HISTORIC LANDMARK COMMISSION
JUNE 25, 2012
APPLICATION FOR A CERTIFICATE OF APPROPRIATENESS
C14H-1977-0021
Swedish Log Cabin
2220 Barton Springs Road

Repair the foundation and lower logs and replace windows, chinking and daubing.

RE: Swedish Cabin at Zilker Botanical Gardens
2220 Barton Springs Road
Austin, Texas

RE: **Assessment and Prescriptive Narrative of Recommendations for
Swedish Cabin at Zilker Botanical Gardens**
2220 Barton Springs Road
Austin, Texas

PHOTO C – non-metallic cable

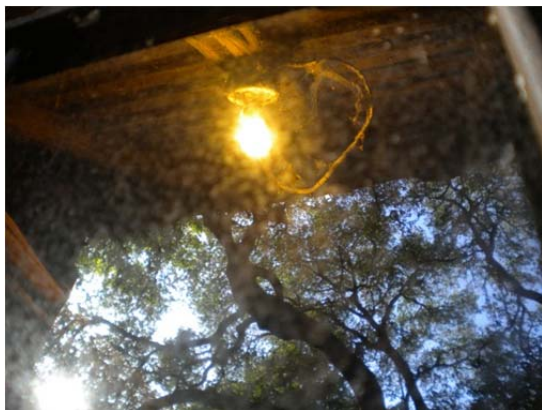
Non-metallic cable with a plug is plugged into that receptacle and loosely routed up the wall and over to the light fixture. **See PHOTO C.**

Demolition - All other electrical wiring in the cabin shall be demolished and removed (taking care to not damage the cabin log surfaces).

PHOTO F – Proposed new light fixtures (2)

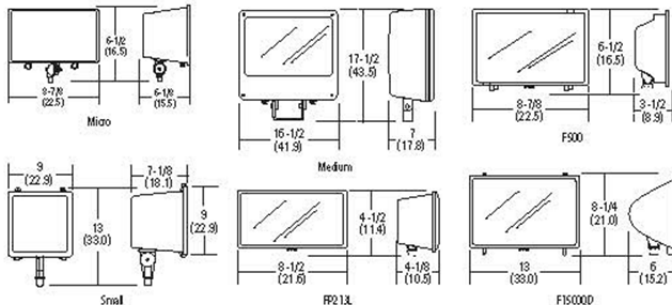
New Light Fixtures - Mount one Lithonia model FP213L 120 M12 compact fluorescent floodlight, or equal, to each of two junction boxes, aiming up to illuminate the underside of the roof. Fixtures shall be wet rated, with 2 – 13W energy star rated compact fluorescent lamps, 3000K color. **See PHOTO F.**
